Title of Change:	Update of NCV7462DQ1R2G datasheet
Effective date:	30 Nov 2022
Contact information:	Contact your local onsemi Sales Office or Jelle.Genne@onsemi.com
Type of notification:	This Product Bulletin is for notification purposes only. onsemi will proceed with implementation of this change upon publication of this Product Bulletin.
Change Category:	Information Only
Change Sub-Category(s):	Datasheet/Product Doc change

Update of NCV7462DQ1R2G datasheet:

From	To
Datasheet	NCV7462/D, Rev. 6	NCV7462-1/D, Rev. 0

Figure 3. Application Diagram

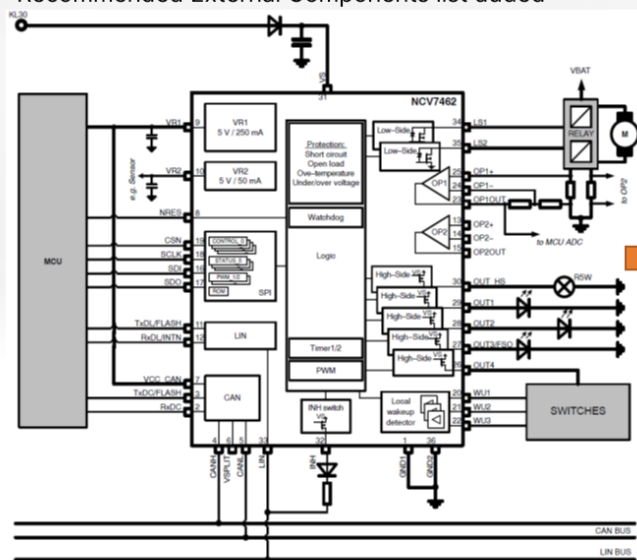
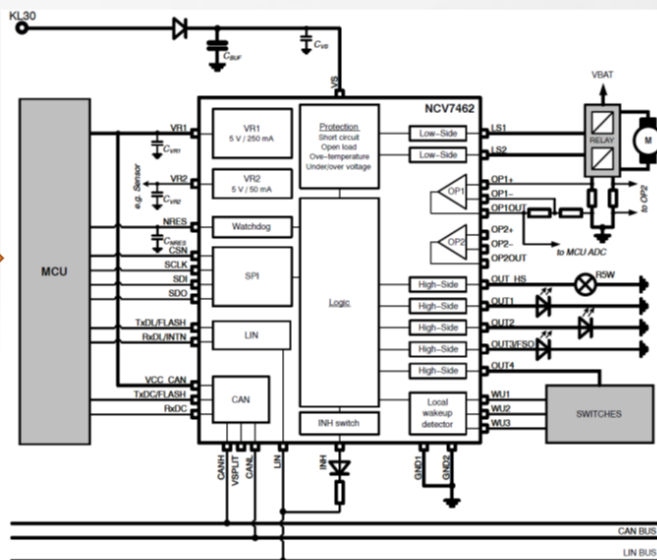
Application Diagram updated

Recommended External Components list added

Figure 14. Watchdog Operation

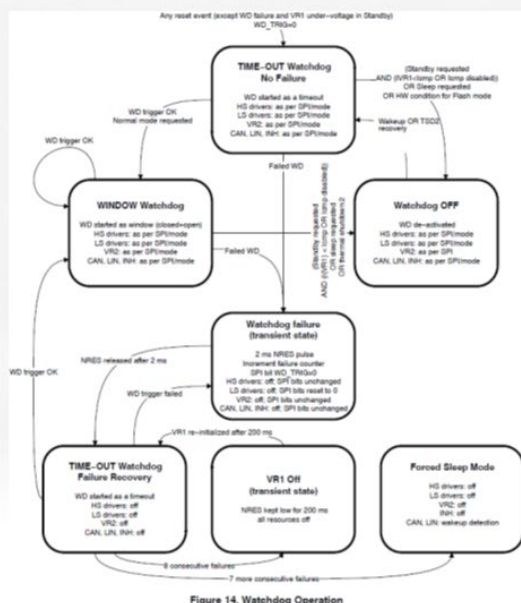
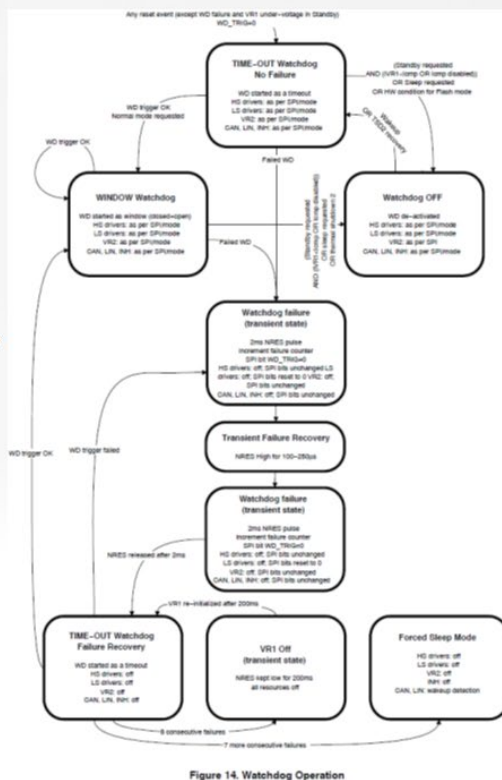
Watchdog failure behavior description updated

Failure: If the watchdog is not triggered correctly (trigger not sent during timeout or open window; or sent during the closed window), reset is generated on pin NRES and the “WD_TRIG” bit is reset to low. After the NRES release, the watchdog always starts in the timeout mode. Watchdog failures are counted and their number can be read from the SPI status registers. After eight watchdog failures in sequence, the VR1 regulator is switched off for 200 ms. In case of seven more watchdog failures, VR1 is completely turned off and the device goes into forced sleep mode until a wake-up occurs (e.g. via the LIN or CAN bus). First successful watchdog trigger resets the failure counter.

Failure: If the watchdog is not triggered correctly (trigger not sent during timeout or open window; or sent during the closed window), two reset pulses are generated on pin NRES and the “WD_TRIG” bit is reset to low. After the **second** NRES release, the watchdog always starts in the timeout mode. **NRES pulses due to watchdog failures are counted** and their number can be read from the SPI status registers. **After four watchdog failures** in sequence, the VR1 regulator is switched off for 200 ms. **In case of three more watchdog failures**, VR1 is completely turned off and the device goes into forced sleep mode until a wake-up occurs (e.g. via the LIN or CAN bus). First successful watchdog trigger resets the failure counter.
